## RPRC RETURN LETTER

Application Number: 2022-0602

Street Location: 5 SHIPPEN RD

Re: RPRC Return Letter, dated August 2, 2022  
5 Shippen Rd  
Application No. 2022-0602

DATE 9/1/2022

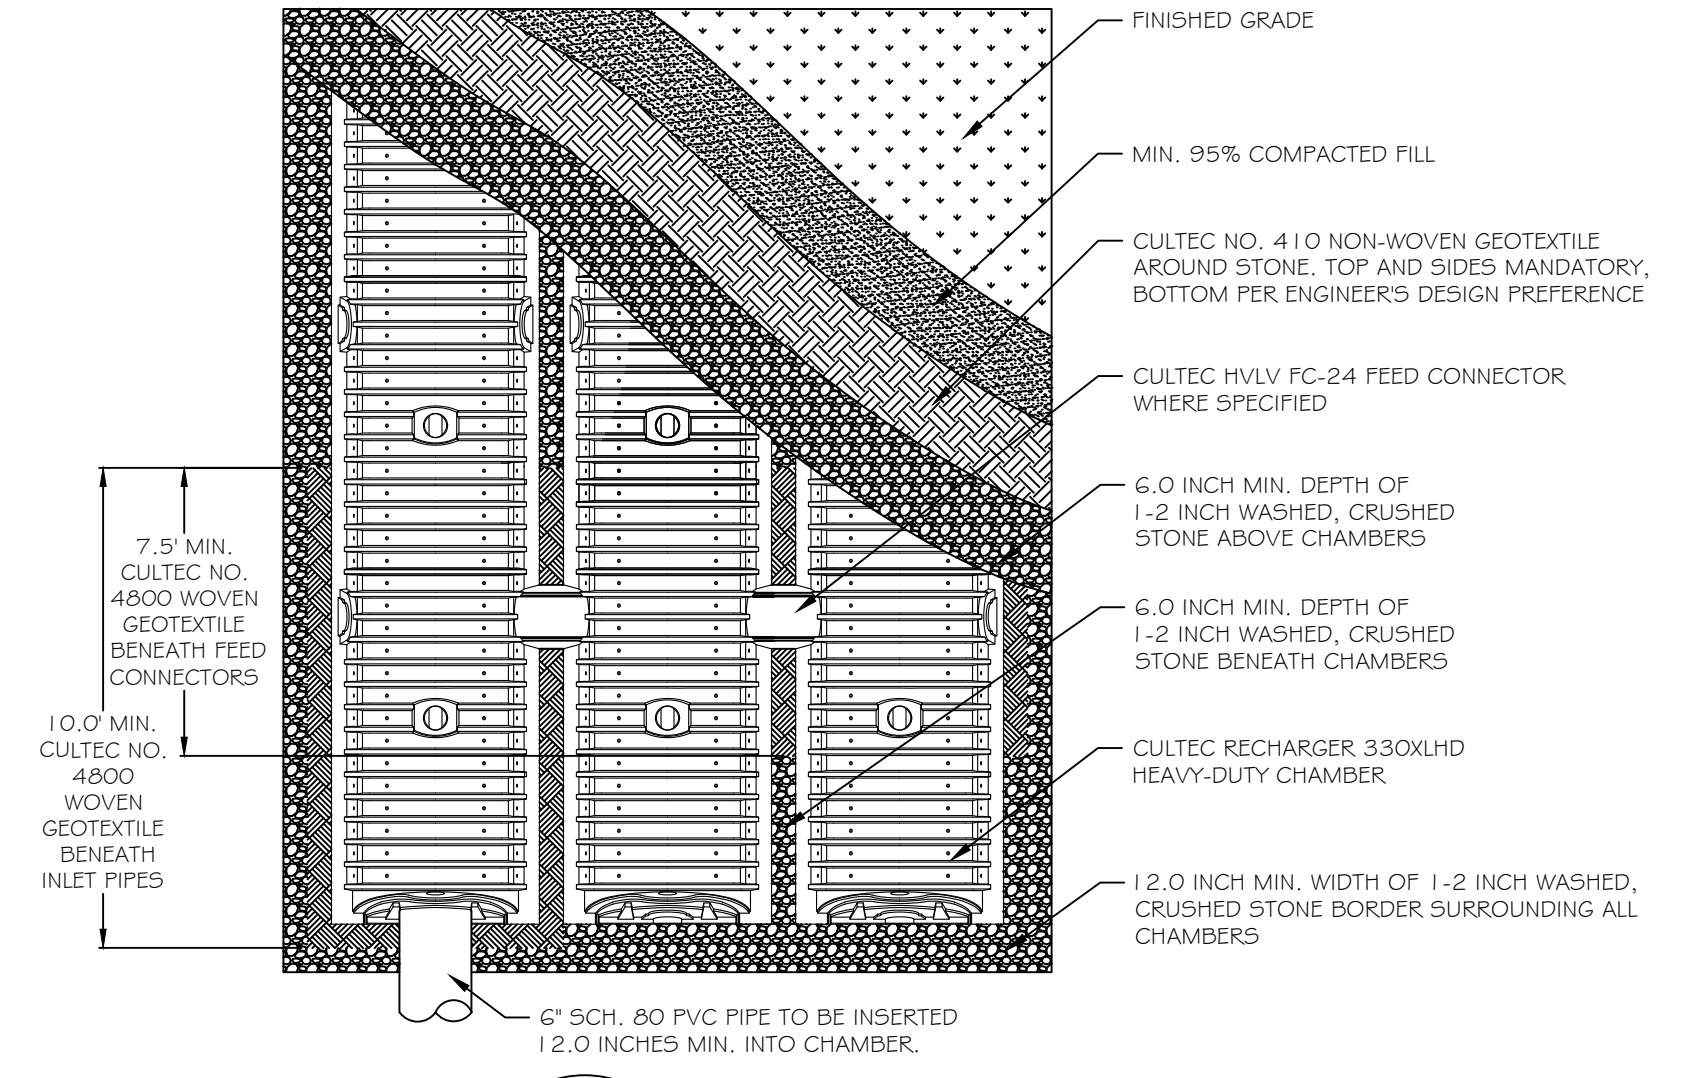
- Provide stormwater mitigation and design calculations for the runoff generated by the net increase in impervious surface for the 25-year, 24-hour design storm event. Provide details of the stormwater mitigation system.

- The plan shall illustrate the drainage pipe connections on the site plan. Include the size, slope and material.
- Include erosion control measures on the plan, including, but not limited to, temporary silt fence, etc.

- A copy of the Gross Land Coverage Calculations Worksheet has been submitted.
- Per conversations with the Town Engineer, the design capacity for the stormwater infiltrators was calculated to store the 25-year, 24-hour design storm event without reductions for infiltration/percolation into the in-situ soils. A three-foot over-excavation in the location of the infiltrators will be performed in the presence of the Town Engineer to ensure groundwater is not encountered.

- Stormwater volume calculations are provided on drawing SW-101.
- Drainage pipe information is indicated on drawings SW-101 and SW-102.
- Erosion control measures are shown on drawings S.01, SW-101 and SW-102.
